Parkes Bypass

Submissions report

Figure 2-2: Cross section of the proposed roundabout at Condobolin Road

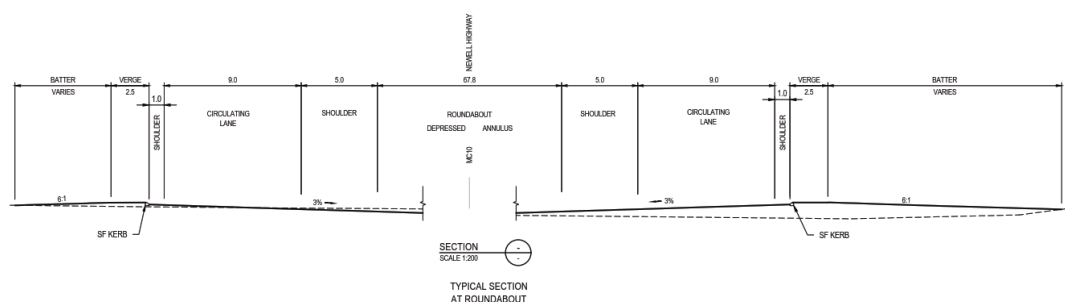
- Concerns that roundabouts are unsafe for heavy vehicles
- Concern that the roundabout design does not include overtaking lanes
- Comment that the five-way roundabout design (as identified as an option in the value management workshop) was not chosen, which would have reduced impacts to residences on Back Trundle Road

- Suggestions to construct a bridge instead of a roundabout at Condobolin Road, as it would:
 - Provide grade separation of opposing traffic
 - Avoid the need for through traffic to slow before the intersection

The roundabout proposed at Condobolin Road would be a large inverted roundabout structure, which would have its lowest point in the middle of the intersection (shown in Figure 2-2), which is opposite to a normal roundabout design. This type of roundabout has been chosen as it improves the stability of heavy vehicles when using the roundabout compared to normal roundabouts. The roundabout would be designed specifically for PBS3a vehicles, an 80 km/hr speed limit, the future expected demand volumes and would be compliant with Transport for NSW's design standards. Traffic modelling indicates this intersection would operate with a high level of service for current and future demand scenarios. As a result, this roundabout would be safe for PBS3a heavy vehicles to navigate and is considered appropriate for the proposal.

Figure 2-3: Location of new shared path between Brolgan Road and Victoria Street (shown in pink)

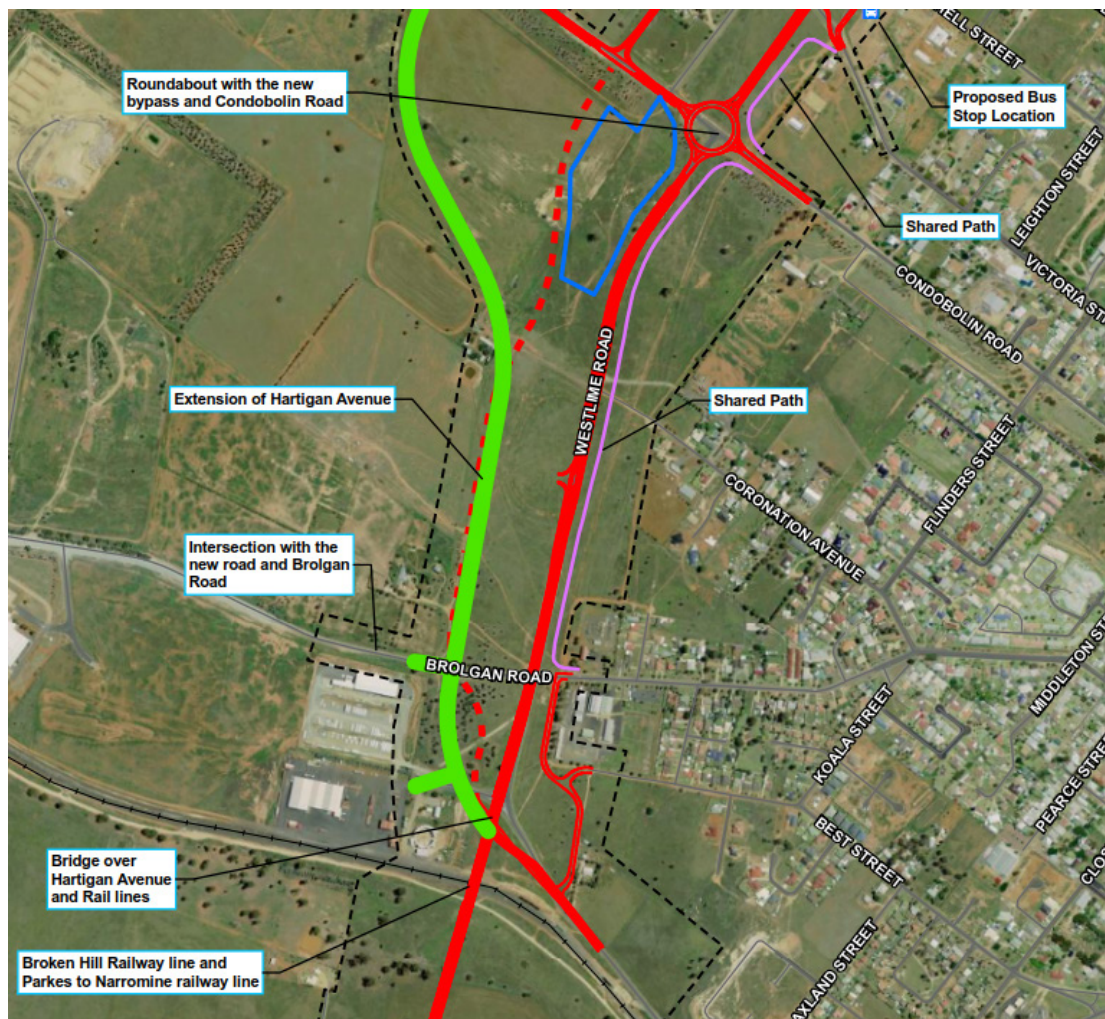
- Comment that the verge of the bypass should have enough room for a marked cycleway.

The proposal design does not incorporate a marked cycleway in the verge of the bypass. However, it does include a shared pedestrian/cycleway bridge and new shared paths for pedestrians and cyclists parallel to the bypass (refer to Section 4.1 and Figure 2-3), which are considered safer options and would increase the provision of dedicated active transport infrastructure within Parkes.

Figure 2-4: Typical design with increased shoulder width for property access

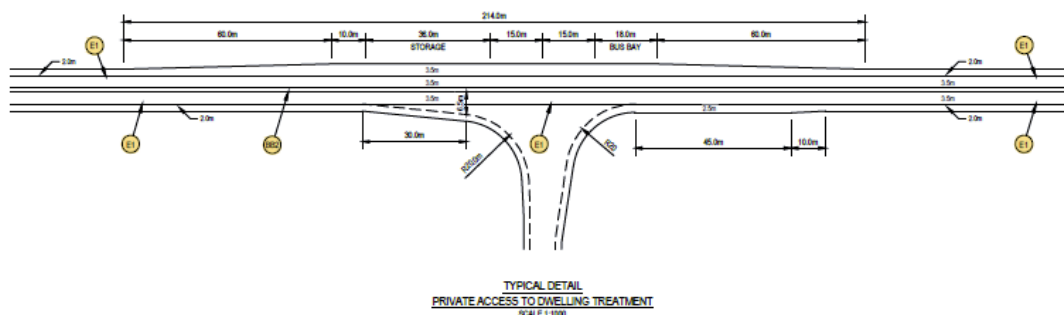
- Suggestion to include a right-hand turning lane for southbound traffic turning from the bypass onto Barkers Road
- Comment that an additional right-hand turning lane at the southern tie-in would not disrupt the flow of traffic and would reduce the risk for several residences.

Right-hand turning lanes at the southern tie-in were considered in early versions of the intersection design, however were not considered justified due to the low traffic volumes that would use the turning lane.

The proposal incorporates a three-metre shoulder width near the southern tie-in (shown in Figure 2-4), which is wider than the two-metre shoulder width that is typical elsewhere along the bypass. This increase in shoulder width has been provided as an alternative safety treatment to a right-hand turning lane, which would allow light vehicles to pull into the shoulder while waiting to turn into Barkers Road. This is a common design feature along the existing Newell Highway for property access and intersections with local roads that have low vehicle volumes.

Figure 4-1: Indicative cross section for the local vehicle bridge

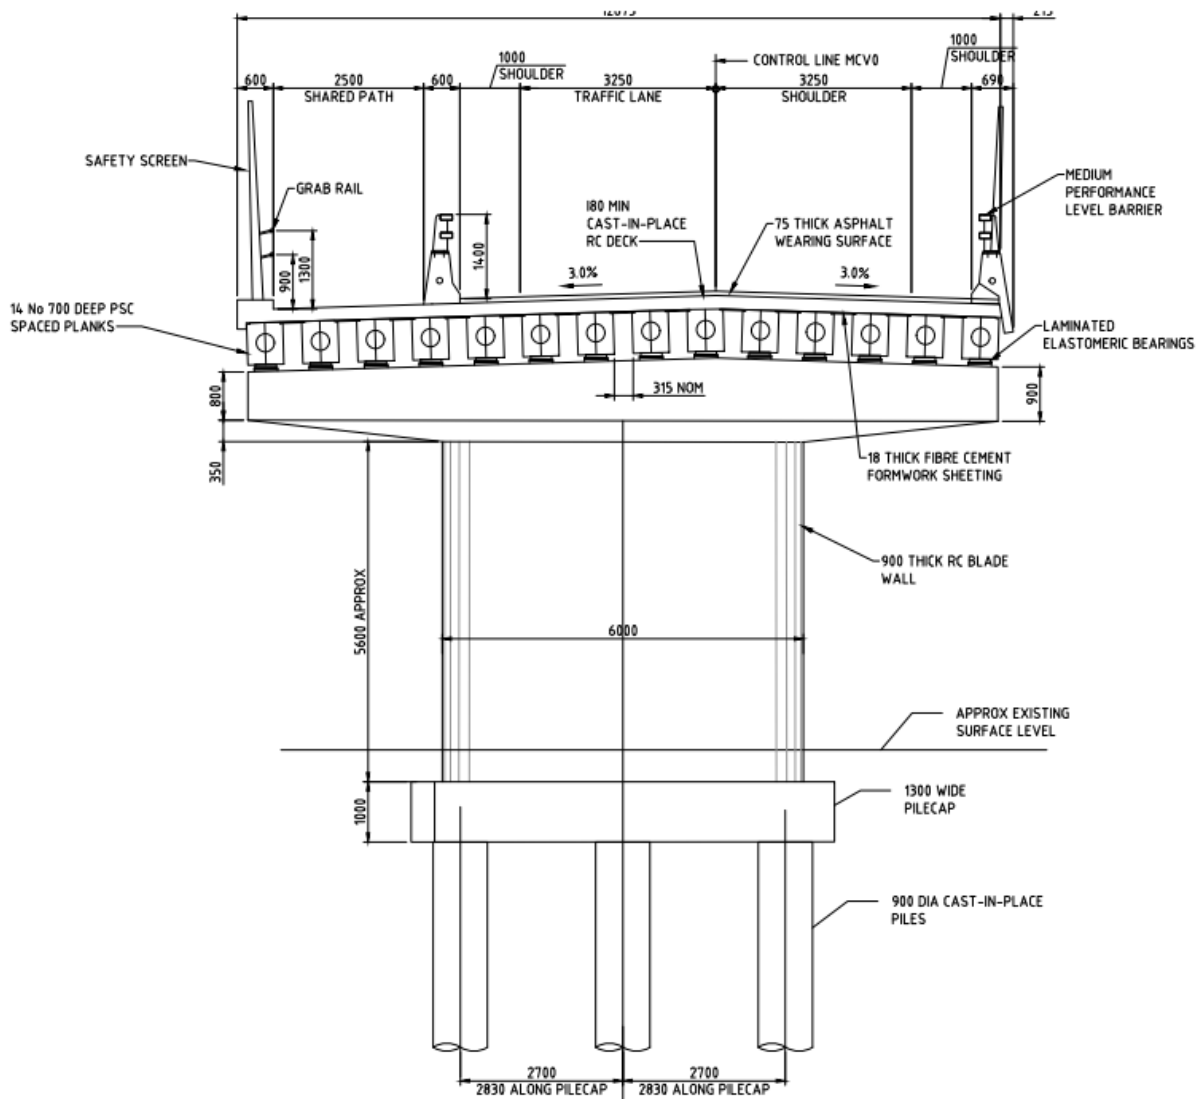
- Comments that including the upgraded light vehicle bridge design in the proposal would:
 - Provide safer and easier access to Parkes Christian School for parents, students and residents
 - Provide direct access over the bypass to/from Parkes town centre and increase east-west connectivity in Parkes
 - Provide an alternate route for emergency vehicles
 - Reduce traffic and potential delays at the proposed Condobolin Road roundabout and the intersection between the Hartigan Avenue extension and Henry Parkes Way
 - Result in a minor increase in cost compared to the overall project cost
 - Not be difficult to construct
 - Show that Transport for NSW is listening to local recommendations.

The local vehicle bridge design includes (shown in Figure 4-1):

- A three span bridge structure, which would be approximately 46 metres long
- 60 km/hr design speed
- Two 3.25 metre wide traffic lanes with a one metre wide shoulder on each side
- 2.5 metre wide shared path on the southern side for pedestrians and cyclists
- Safety screens and a barrier to separate the shared path from the traffic lanes.

With this alternate design, the proposed local road connection between Victoria Street and Mitchell Street would no longer be required to provide local connectivity, therefore this would be removed from the proposal.

Figure 4-2a: Key features of the revised proposal (Page 1 of 3)

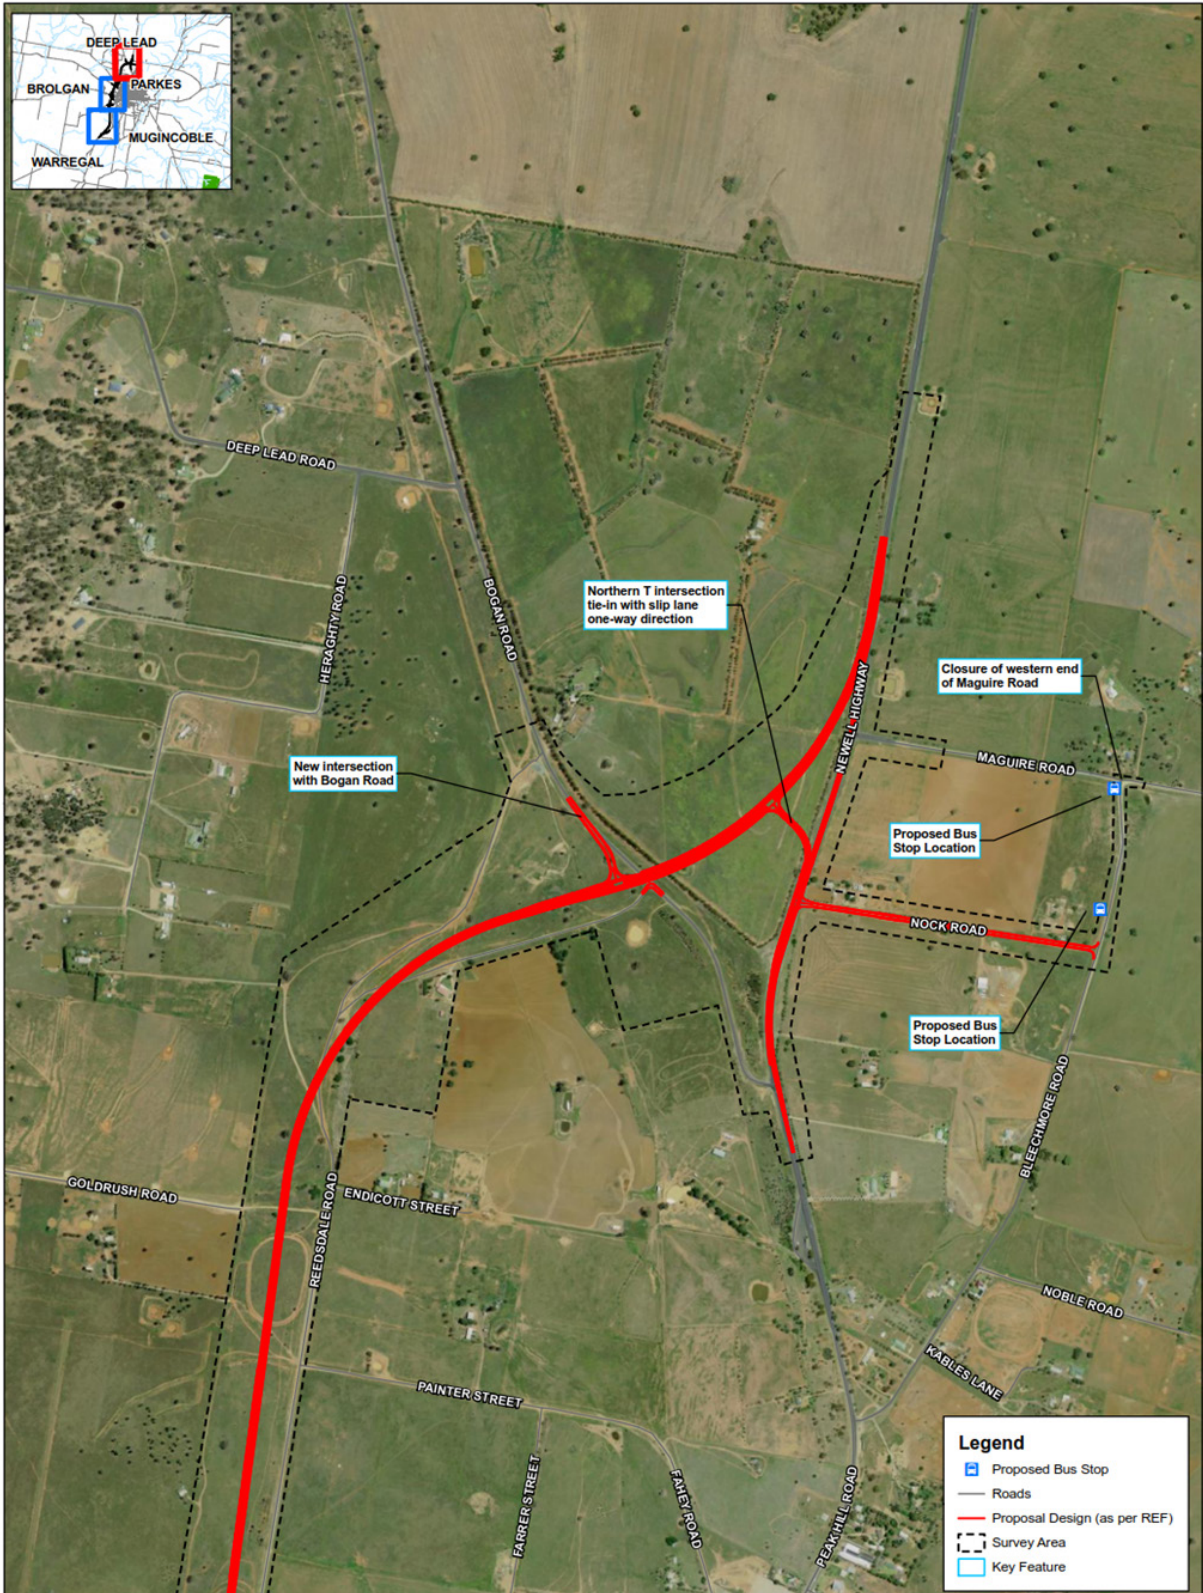
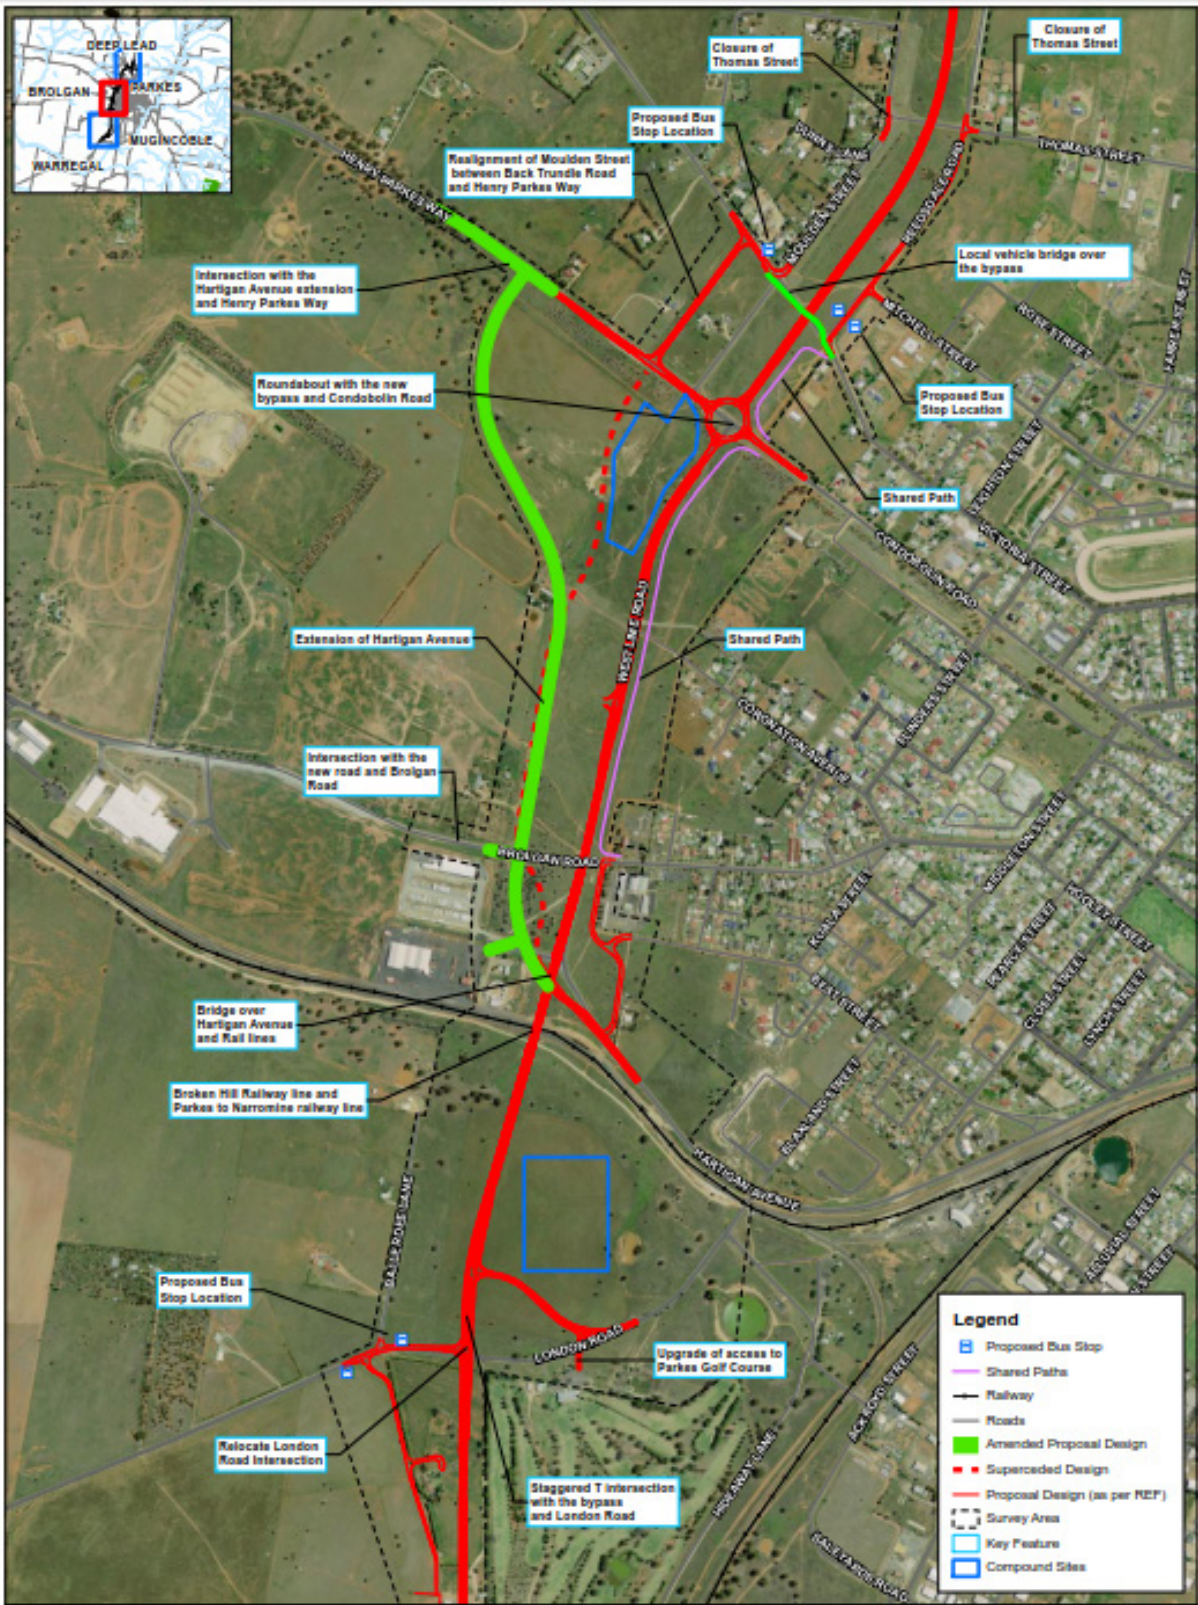
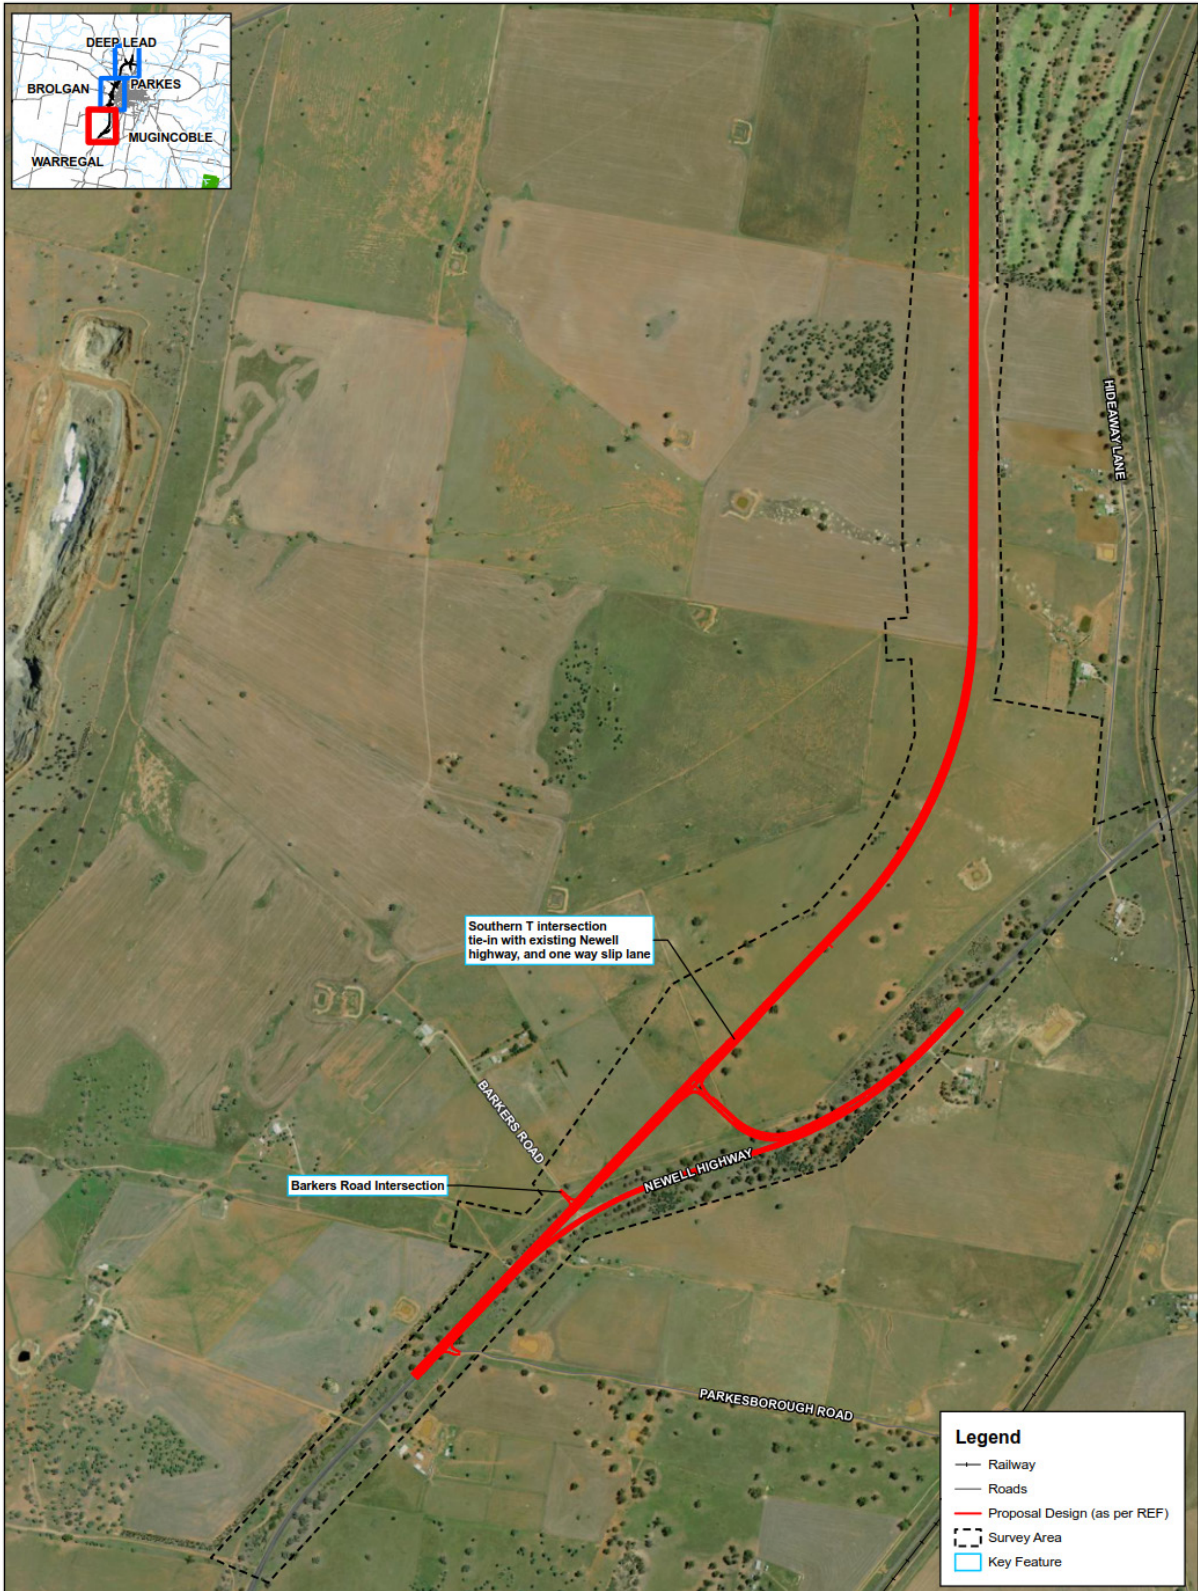
- Suggestion to move the Hartigan Avenue extension intersection with Henry Parkes Way approximately 150 metres west and consider adjusting the angle to a 'Y' shaped intersection to reduce potential amenity-related impacts
- Concern that the Hartigan Avenue extension intersection with Henry Parkes Way would be inappropriate for the expected traffic volumes
- Question why the Hartigan Avenue extension intersection with Henry Parkes Way is required as vehicles could use the nearby Condobolin Road roundabout instead.

Following exhibition of the REF, the proposal design has been refined to include an alternate local vehicle bridge option, more detail on the provision of shared paths and bus stops and an adjustment to the intersection between the Hartigan Avenue extension and Henry Parkes Way. The revised proposal design is shown in Figure 4-2a to Figure 4-2c, with most of the changes in the middle section of the proposal.

The revised proposal design includes a new shared path for pedestrians and cyclists parallel to the eastern side of the bypass (shown in Figure 4-2). This shared path would connect Brolgan Road, Condobolin Road and Victoria Street and the proposed local vehicle bridge near Condobolin Road. This would provide local connectivity, increase the provision of active transport infrastructure in Parkes and provide a safe route for pedestrians and cyclists to cross the bypass.

New bus stops would be provided as part of the proposal design to maintain safe access to bus routes during operation of the proposal (shown in Figure 4-2) including on:

The intersection between the Hartigan Avenue extension and Henry Parkes Way has been moved approximately 100 metres further west, so that it is opposite a vacant paddock and further away from the Condobolin Road roundabout (shown in Figure 4-2). This intersection would be designed for PBS3a vehicles in accordance with Transport for NSW's design standards. This amended intersection location would reduce potential light glare and other amenity-related impacts to existing residences on Henry Parkes Way. It has also been considered in additional heritage and biodiversity assessment, as it extends beyond the original survey area in the REF (refer to Chapter 5).
